ADDENDUM #04

DATE:	September 29, 2023	PROJECT NO.:	Project # 20229080 CRSA Project # 21-031
TO:	Gramoll Construction 155 S. 750 W. North Salt Lake, UT 84054	PROJECT:	Rio Grande Depot Seismic 300 S. Rio Grande St. SLC, UT 84101

This Addendum forms a part of the Contract Documents and modifies the original Bid Documents dated October 3, 2022 as noted below. Acknowledge receipt of this Addendum in the space provided on the Bid Form. Failure to do so may subject the Bidder to disqualification.

AE001

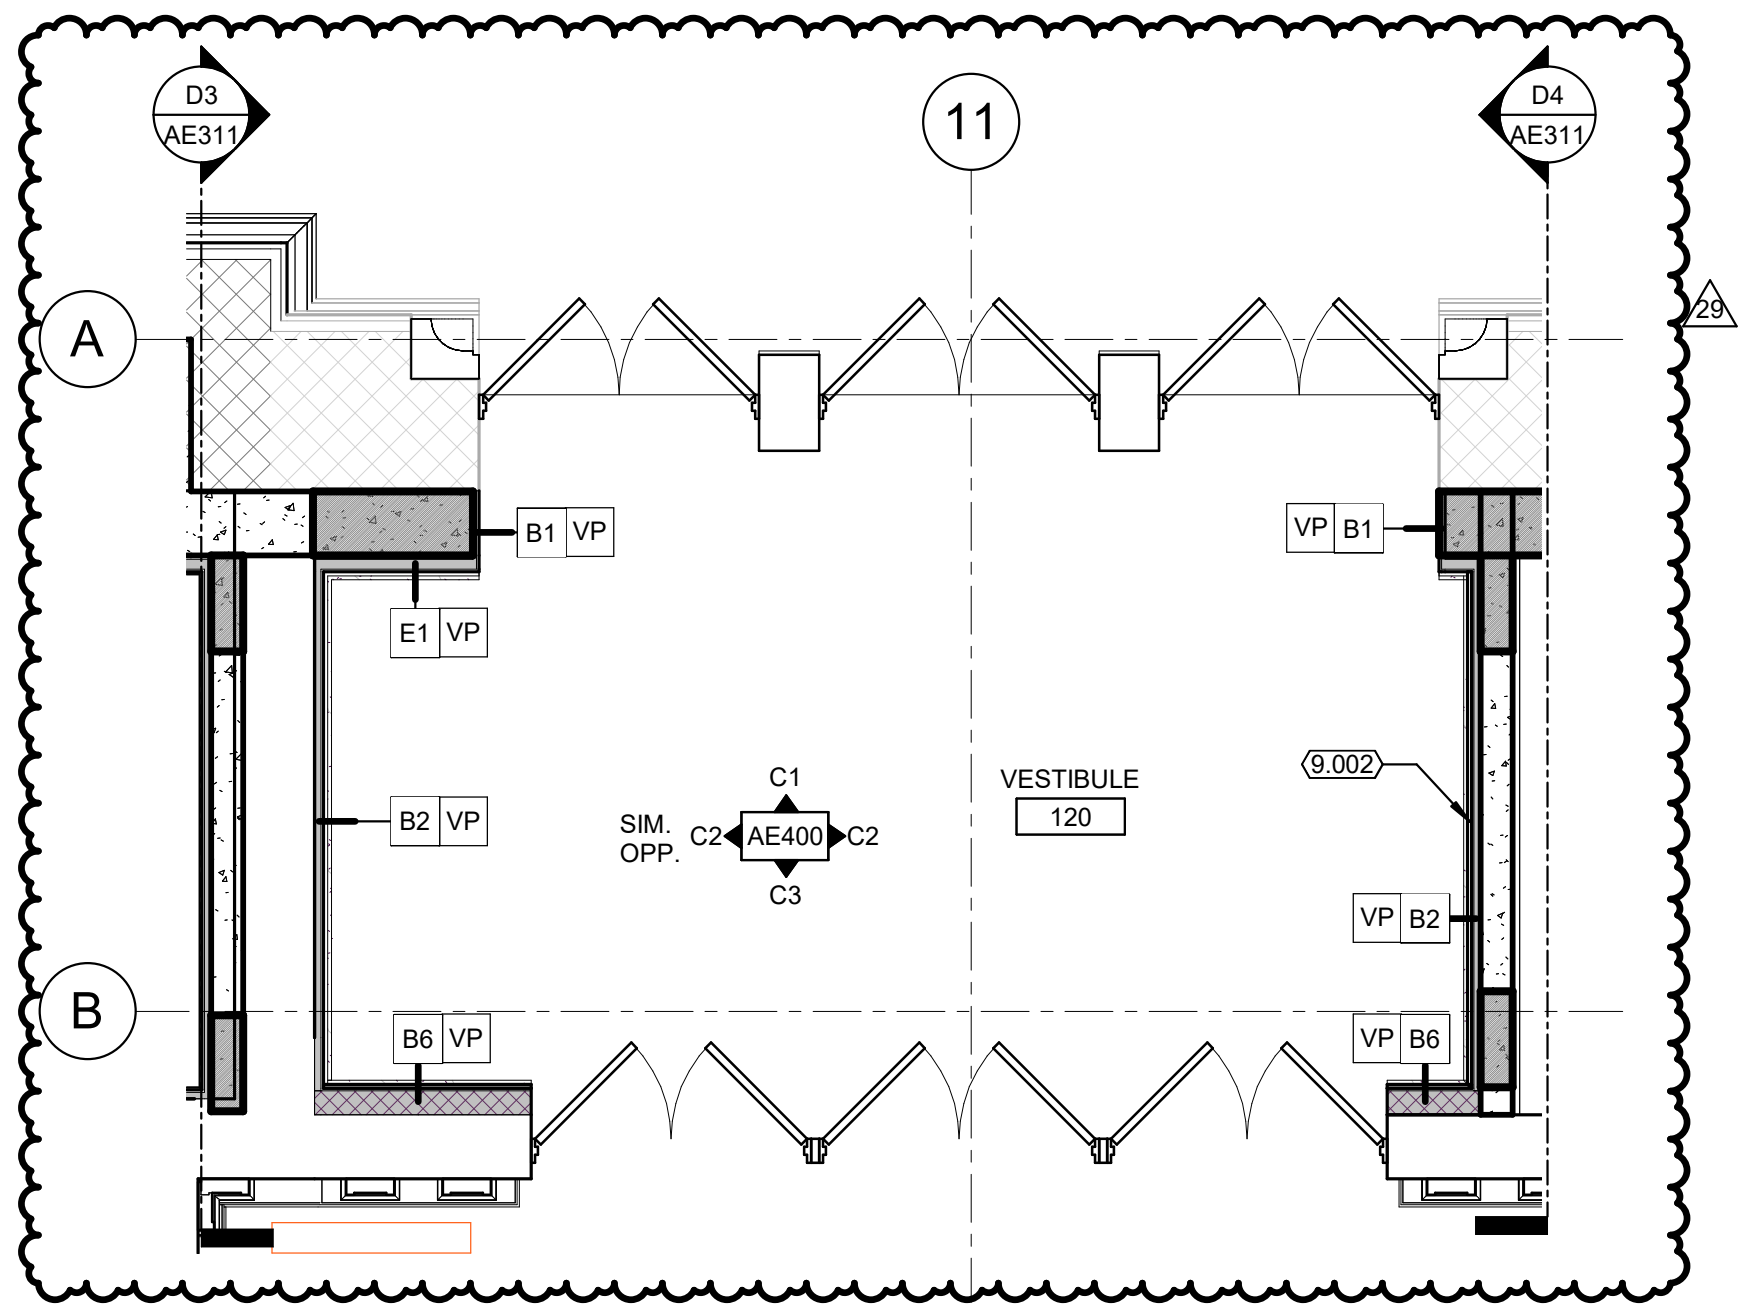
VI-1 AE001: Updated wall type B5. Added wall types B7 and VP. Moved wall type C1 detail to bottom row.

AE400

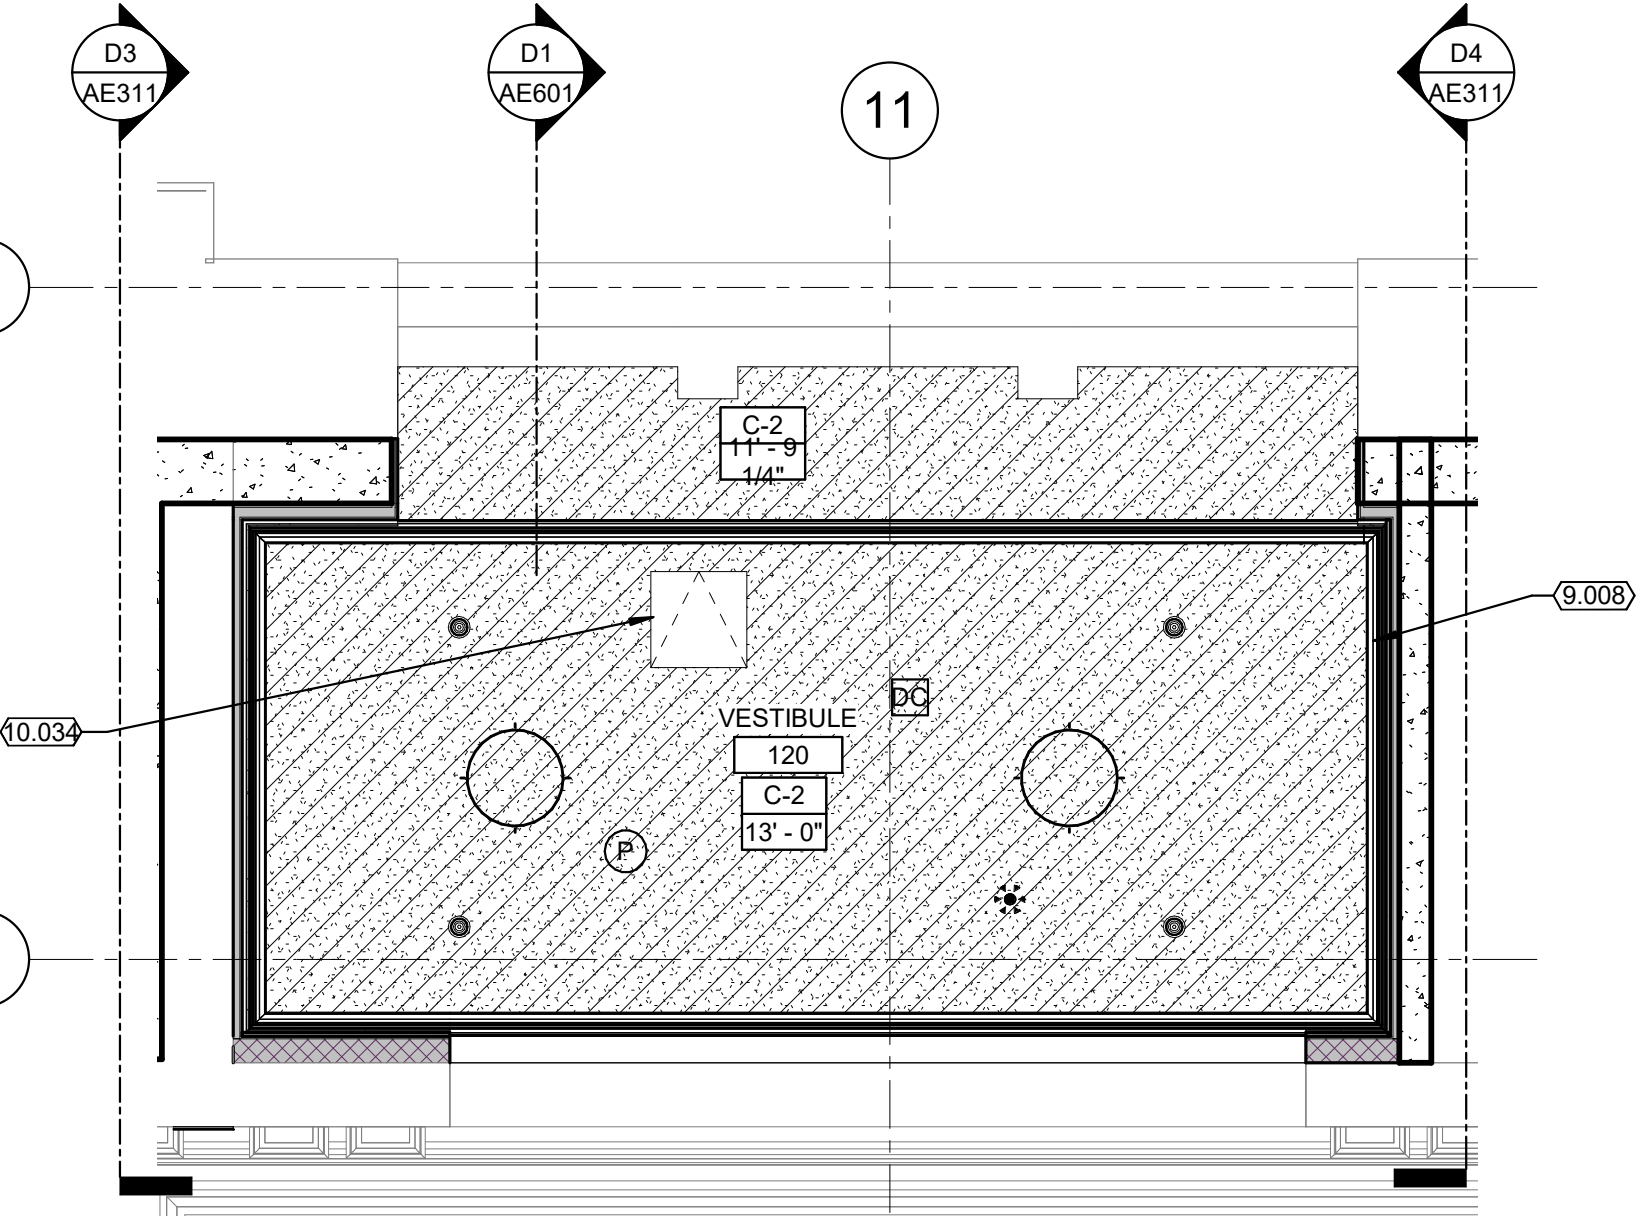
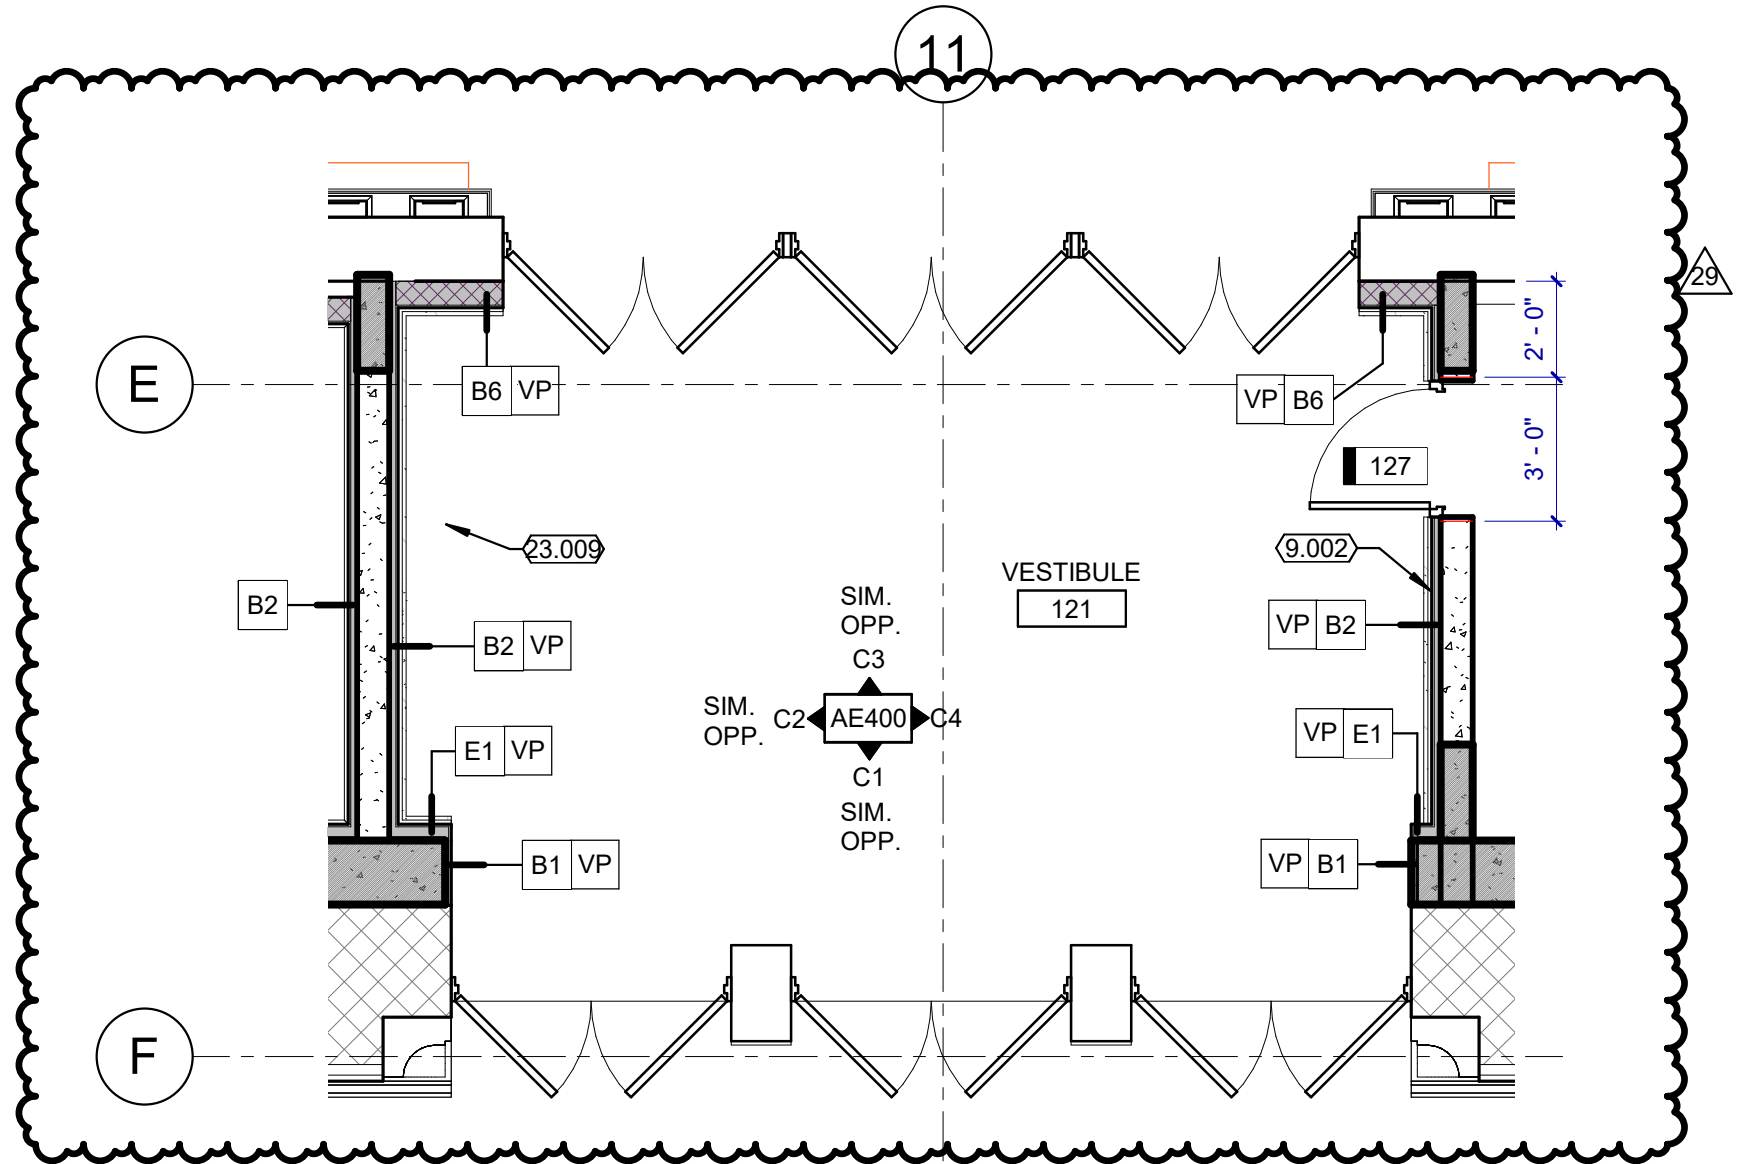
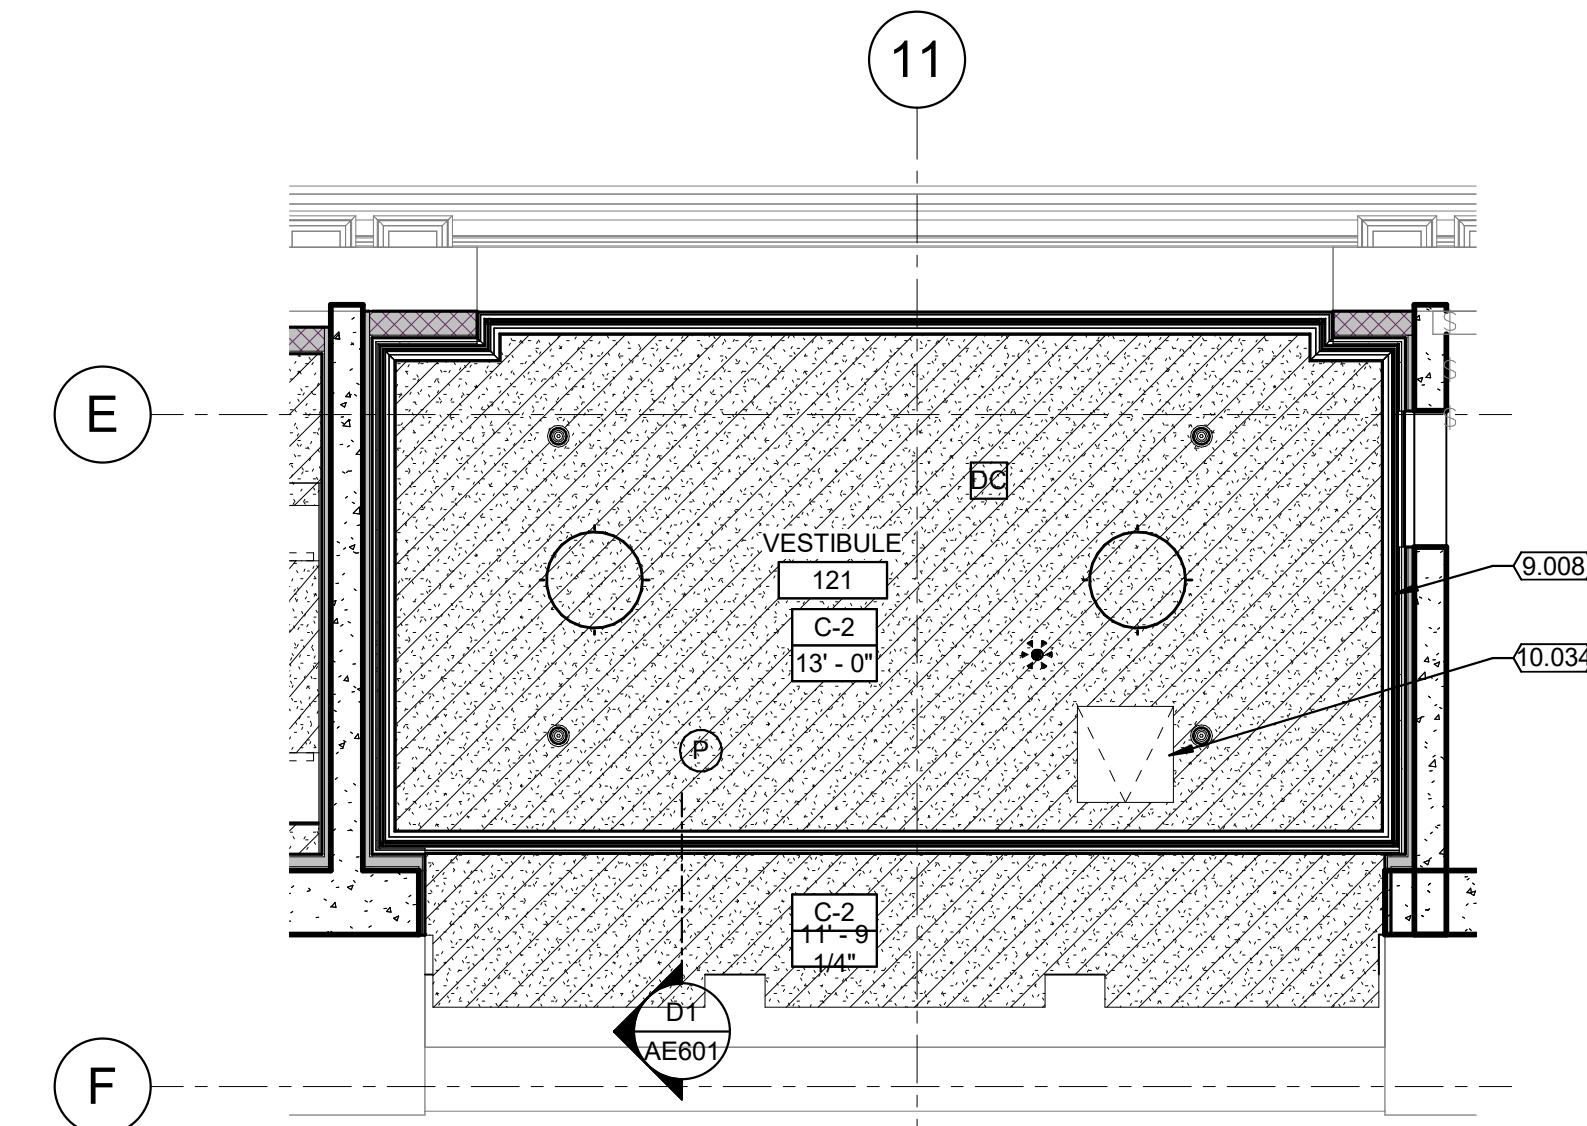
VI-2 AE400: Added VP wall type to plans.
